Agenda for Screening Committee 307 ITEM No. 64:2012

DELHI DEVELOPMENT AUTHORITY

Sub.: Partial modification in the LOP of Bindapur, Pkt. 4 in Zone K-II (Dwarka) for accommodating UGR plot. (No: F1(49)12/Plg./Dwk./Pt. I)

64:2012 Partial modification in the LOP of Bindapur, Pkt.4 in Zone K-Il Dwarka for accommodating UGR plot. File no. F.1(49)12/Plg./Dwk./Pt.1

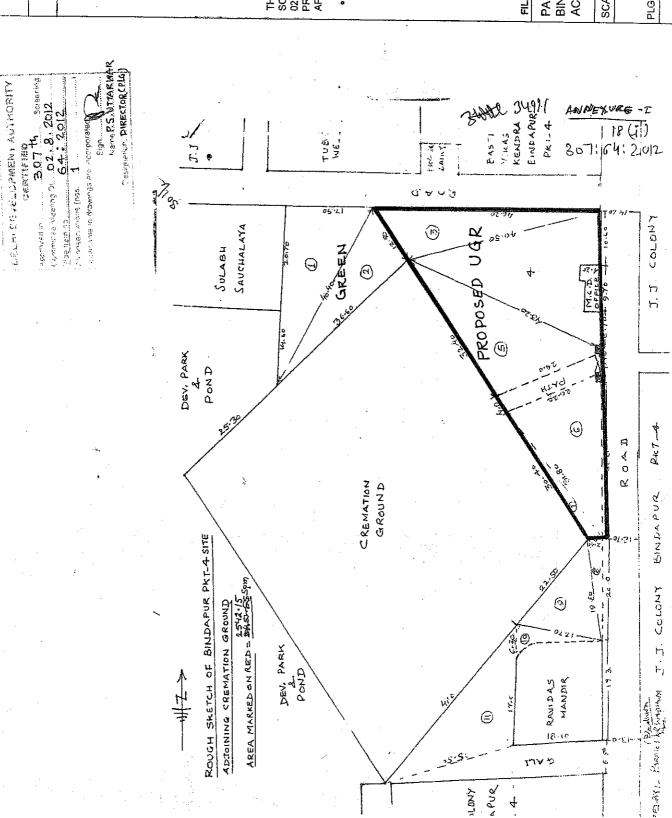
The areas of triangles of the survey map (of the Annexure –I of the agenda) numbering 3,4,5,6 and 7 will be used for UGR. The areas of triangles of the survey map(of the Annexure –I of the agenda) numbering 1 and 2 will continue to remain as a part of the Landscaped Green.
